## Century Club

### **Detailed reply to the queries raised by the members on following Project Works**

**Ref.: Notice of Meeting dt.08.12.2025 - Special General Meeting 04.01.2026 point no. 3**

## 6.2. Adequacy Check for Column

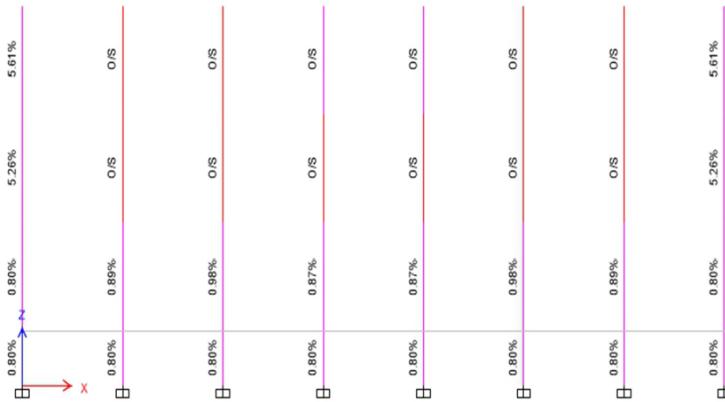
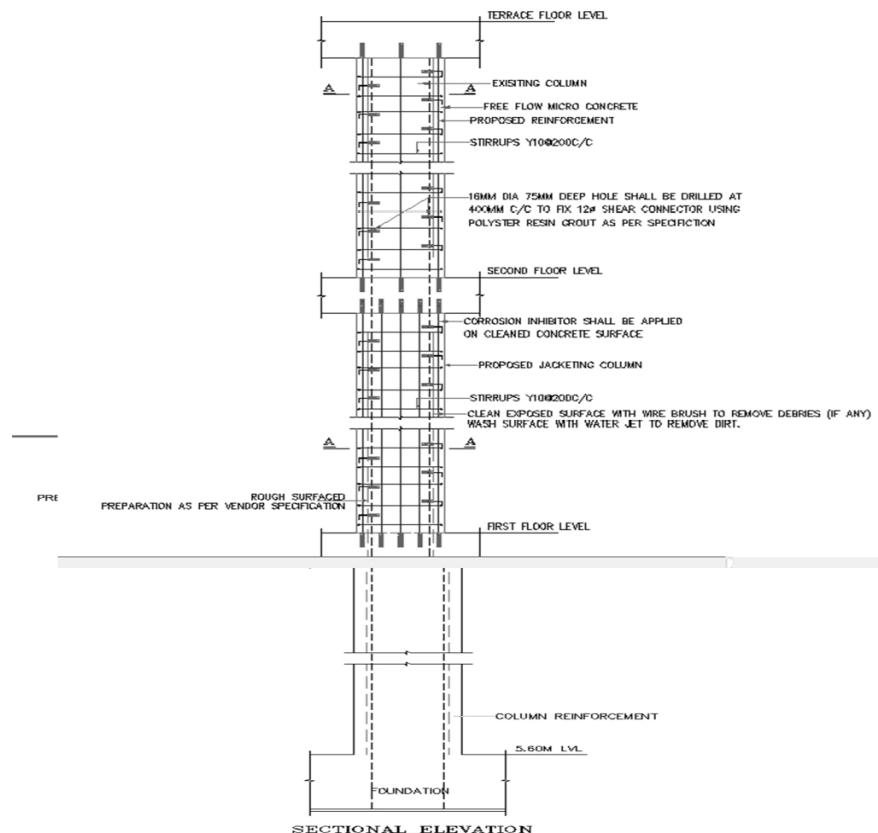
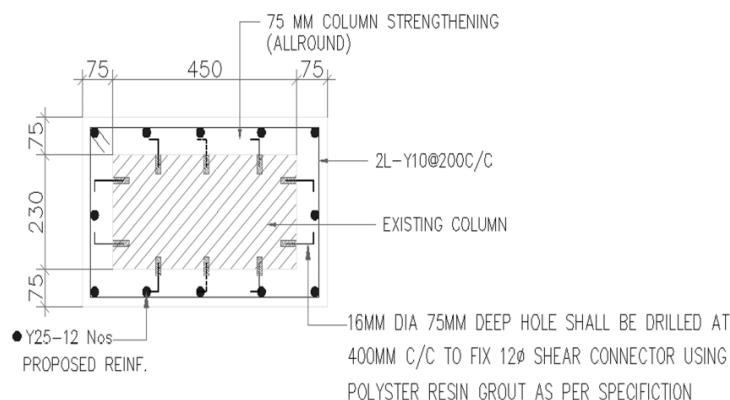
6.2.1. As per Etabs Analysis Column Design is Checked. And it is found existing Columns in 1<sup>st</sup> & 2<sup>nd</sup> floor having sizes 230x450 are **Inadequate**

Remedy : Column shall be retrofitted with column size 375x600 with additional reinforcement ( Refer Below Details)

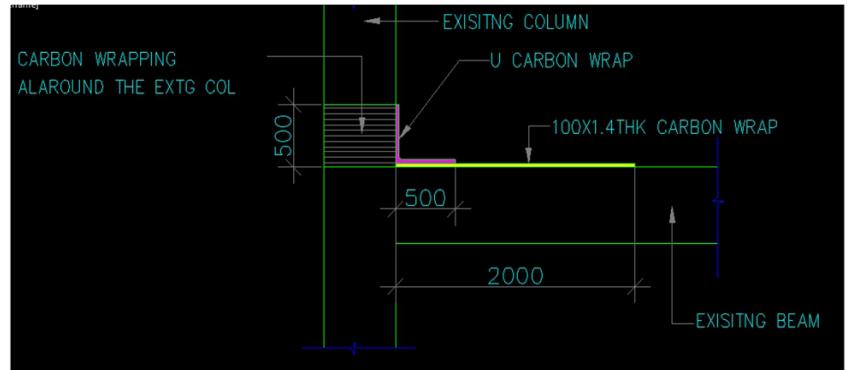
Ast Provided **1964mm<sup>2</sup>** is less than Ast Required **3128mm<sup>2</sup>**.

Hence Beam retrofitting is required.

Remedy : Strengthening of Main Beam with Carbon laminates is proposed ( Refer drawings)

### 6.2. Adequacy Check for Column

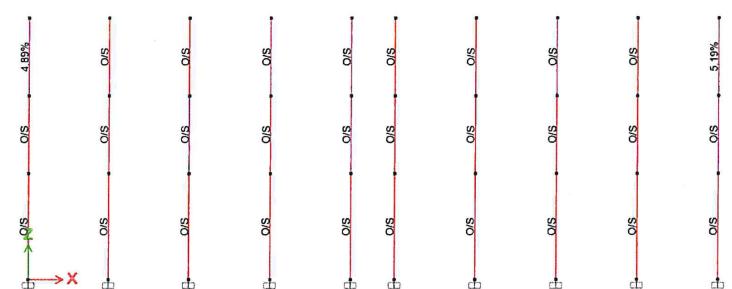
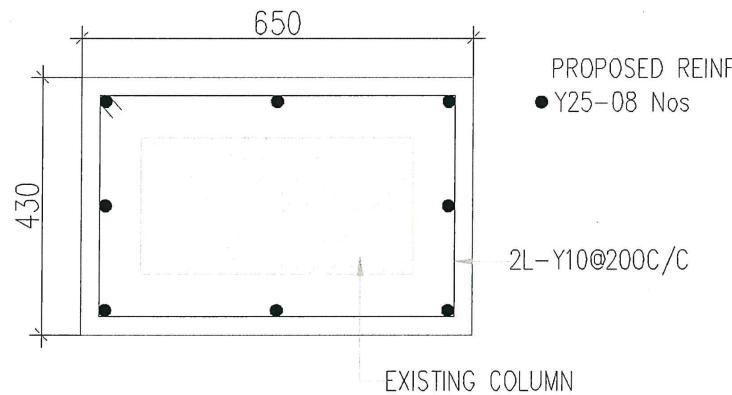
6.2.1. As per Etabs Analysis Column Design is Checked. And it is found existing Columns in GFL , 1<sup>st</sup> & 2<sup>nd</sup> floor having sizes 230x450 are **inadequate**

Sl No	Column No	Levels	Size		Provided Rebar(As per Cover Meter)	Provided Ast mm <sup>2</sup>	Required Ast ( As per Etabs Analysis)	Remarks
			Width	Length				
1	C1	GFL	230	450	4-Y25+4-Y16	2768.00	Columns Fails	As the Existing columns are Not Adequate Strengthening of Columns are proposed . Details are presented in Drawing DRG NO:- SD-01
	C1	1	230	450	4-Y25+4-Y16	2768.00	Columns Fails	
	C1	2	230	450	4-Y25+4-Y16	2768.00	Columns Fails

Remedy : Column shall be retrofitted with additional Concrete & additional reinforcement ( Refer Below Details)

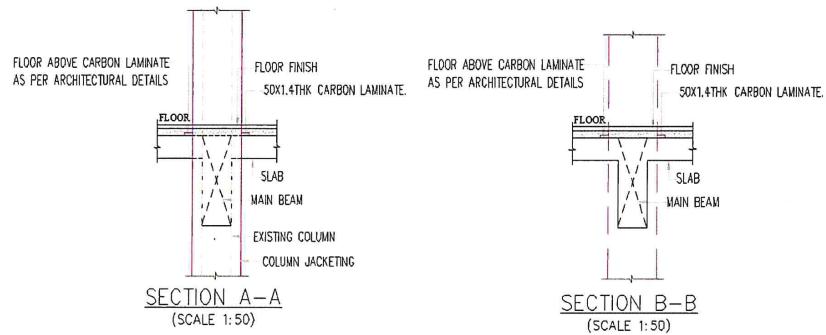
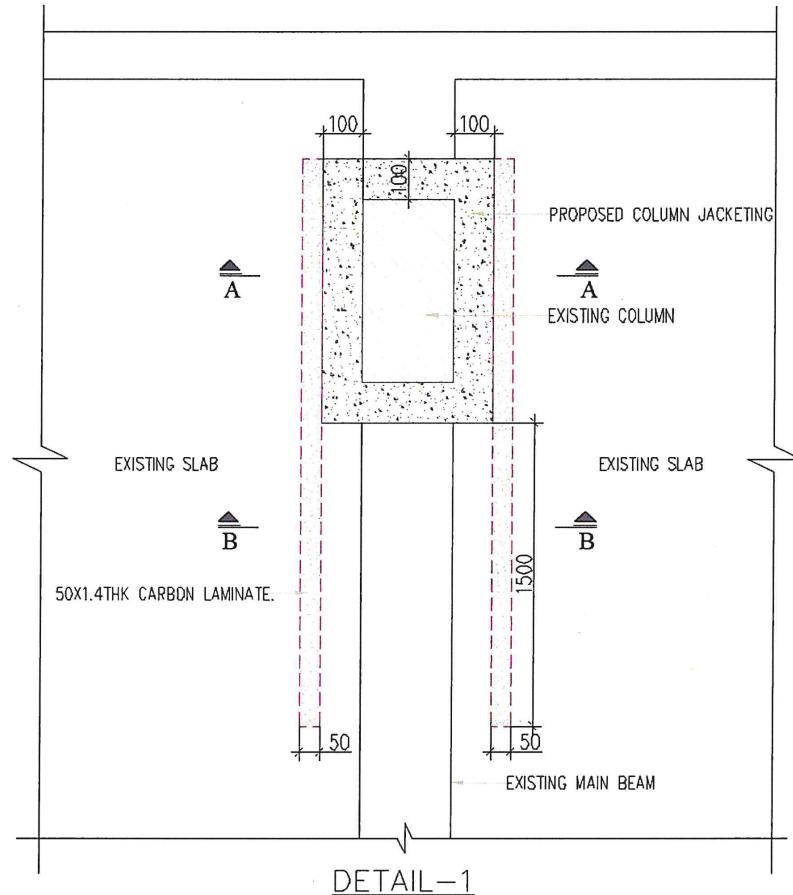
Ast Provided **1964mm<sup>2</sup>** is less than Ast Required **2613mm<sup>2</sup>**.

Hence Beam retrofitting is required.

Remedy : Strengthening of Main Beam with Carbon laminates is proposed ( Refer drawings)

- 1) **PROVIDE SUPPORT TO EXISTING MAIN BEAMS AND SECONDARY BEAMS.**
- 2) JACKETING SHALL BE DONE WITH MICRO CONCRETE UP TO FIRST FLOOR RCC SLAB LEVEL AFTER FIXING THE REINFORCEMENT AS PER DRAWING.
- 3) CUT 25X25mm GROOVE IN EXISTING COLUMN AS SHOWN IN DRAWINGS AND CLEAN THE SURFACE
- 4) PROVIDE & FIX THE CARBON LAMINATE AS SHOWN IN THE SKETCH AS PER VENDOR DETAILS.
- 5) CONTINUE THE COLUMN JACKETING UPTO SF RCC SLAB LEVEL AND REPEAT THE STEPS 2 TO 4
- 6) REPEAT ABOVE PROCEDURE TILL TERRACE LEVEL.

## 7. Construction Deficiencies of existing structure observed at site

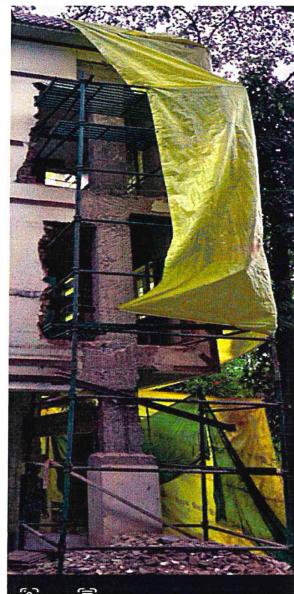
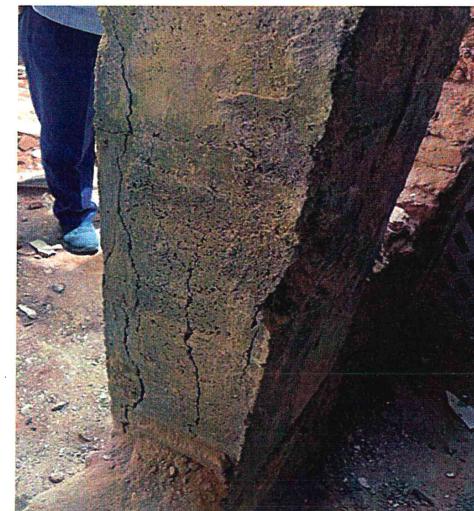
- On Inspection of columns after removal of the brick work around and removal of column plaster, it is seen that the column alignment is not truly vertical and eccentricity is 25 to 50mm.

- Cracking observed in the existing column

Remedy : To address the above encasement of 100m all-round is suggested

**b. In Beam**

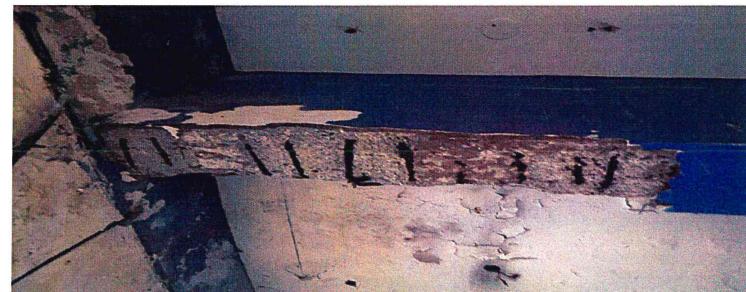
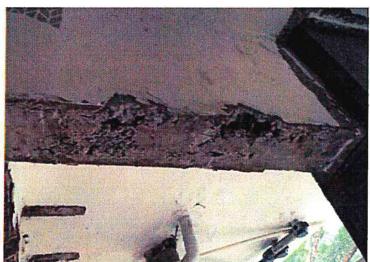
On removal of brick work below beams - lot of Honey comb, cavities and poor concreting in cover zone is seen. Also, reinforcement is slightly corroded. In view of above beam strengthening is required.

**Retrofitting of beam bottom: Brickwork below main beams shall be removed by 450 mm and inspected for requirement of repair**

1. Remove Loose concrete in the cover Zone
2. Apply anti corrosive paint to the exposed reinforcement
3. place 2"x2" MS weld mesh & fix the same in position with connectors provided at 1m c/c
4. finish the same with structural grade plaster using polymer modified compound
